Sigtronics ICS Load Modification Instructions

Intercom Models: **Sport 200**
SPA-400
SPA-600

SDB-800
ST-400
ST-600

The example below is for a Sport 200 intercom. The resistor modification applies to all listed intercoms.

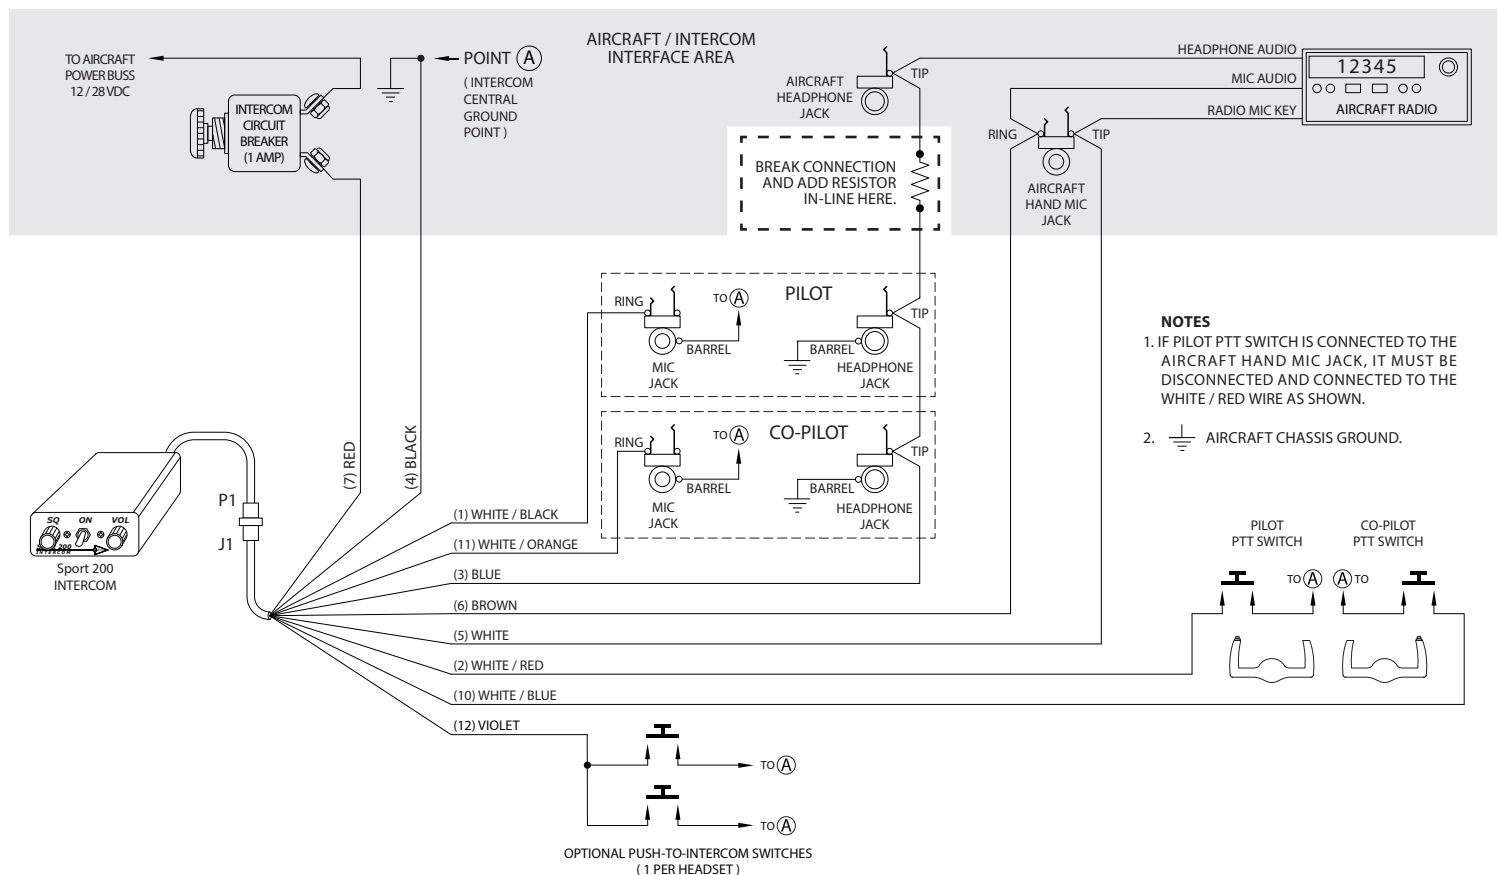
This modification is used when a Sigtronics Intercom is connected to a radio or audio panel which has a low impedance headphone output (less than 100 ohms). This is most common with some Narco equipment (CP-135, CP-136, and MARK 12D for example) and "home made" audio select panels.

Symptoms Are: Intercom audio volume is weak or non-existent.
Transmit function is normal on VHF radio.
Receive function is normal on VHF radio.

Verification: Disconnect the intercom headphone wire (blue) from the radio or audio panel. Make sure that the blue wire is still connected between the intercom and all intercom headphone jacks. If the maximum intercom volume level is now approximately 30% or more greater than when the blue wire was connected, then this modification will solve the problem.

Solution: Add a 1/4 or 1/2 watt resistor per the drawing below. The value of the resistor most commonly used is 220 ohms, however, optimum performance can be achieved by selecting the value right for your particular installation. The resistor can be any value between 100 and 1000 ohms and is selected for the best balance between radio receive volume and intercom volume.
